# Technical Service Information

## CHRYSLER A404 SECOND GEAR STARTS (GRIND FLATS)

Figure 1

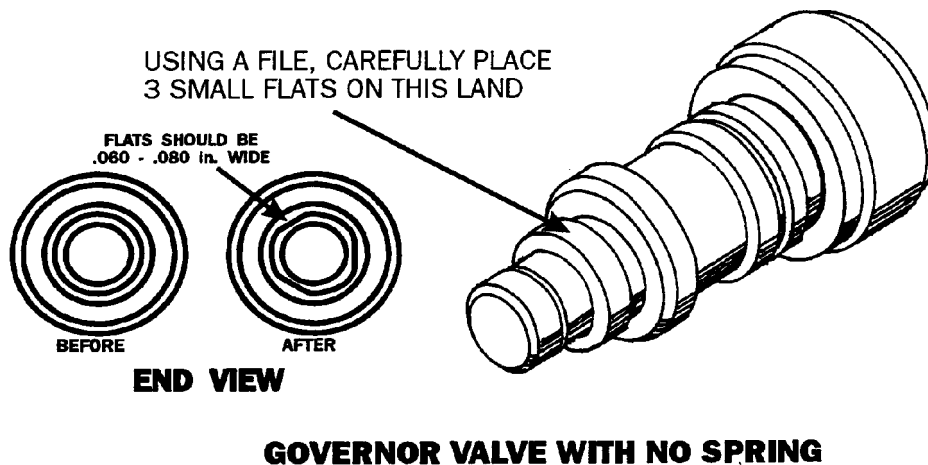
**COMPLAINT:** 2nd gear starts after overhaul.

**CAUSE:** If all other possibilities have been eliminated, the cause may be cross leaks causing governor pressure at a stand still.

**CORRECTION:** Carefully grind 3 small flats on the second land of the free floating governor valve (without spring) to provide an exhaust. see figure 1.
